Fire Risk Assessment

Property assessed: 1-124 Mossbrook Court Kentford Drive Manchester M40 7RE

Client: Northwards Housing

FRA Inspection Date: 14/11/2018
FRA Issued to Client: 30/11/2018
FRA valid to: 30/11/2019
FRA completed by: Savills (UK) Ltd,
33 Margaret Street, London W1G 0JD
T: 020 7409 8737
E: fireriskhousing@savills.com

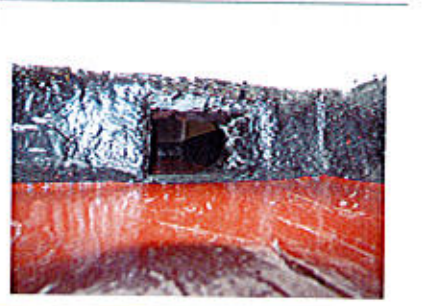
Question - Q.5: If a waste chute is provided within the building are adequate measures in place to limit fire spread/growth? (Consider provision of fusible link dampers and sprinklers etc)				Not Known
<p>Comment: A waste chute is provided in the building, which is located in a permanently ventilated area, separated from the escape route by fire resisting construction of at least 30 minutes. Hopper doors ARE self-closing and HAVE adequate seals. A fusible link damper IS fitted to the base of the waste chute. A sprinkler IS NOT provided at the base of the waste chute. Reported the bin chute hatch is tested daily. No access to the bin chute that runs the height of the building with a vent on the roof.</p>				
<p>Recommendation: Previously Reported - Recommend further investigation is undertaken by a specialist to confirm the condition of the waste chute.</p>				
Priority: Man2	Known Quantity: 0	Potential Quantity: 1	Action ID: 114759
